Access Compliance Report

Public Rights-of-Way

| Intersection ID: 10023017 | Main Street: CENTER_PARK_DR | Cross Street: N/A | Location: NW |
| ADA ID: 921A5BBEECE3 | Ramp Type: PerpDiag | Initial Pass/Fail: Fail | Overall Compliance: No |

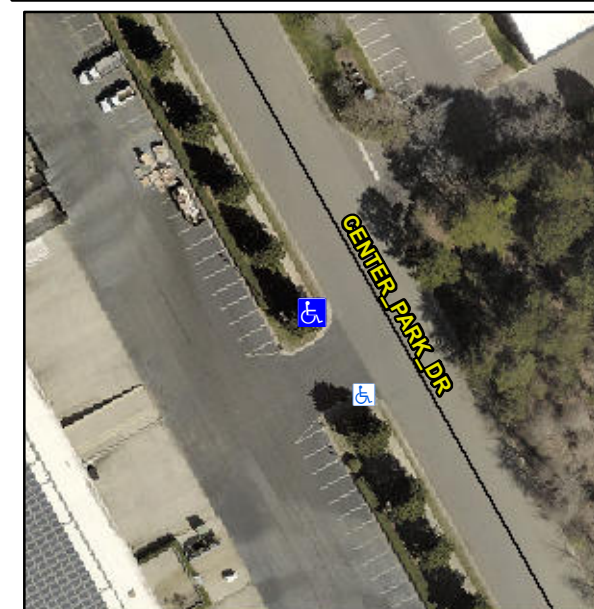
Not Found, R304.5.1, R304.5.3

| Compliance | Description | Data | Compliance | Description | Data |
|------------|-----------------------|------|------------|-----------------------------|------|
| No | Ramp Width (in) | 46.0 | No | Ramp XSlope (%) | 6.3 |

Remove & Replace Curb Ramp With Two New Directional Ramps or Equivalent.
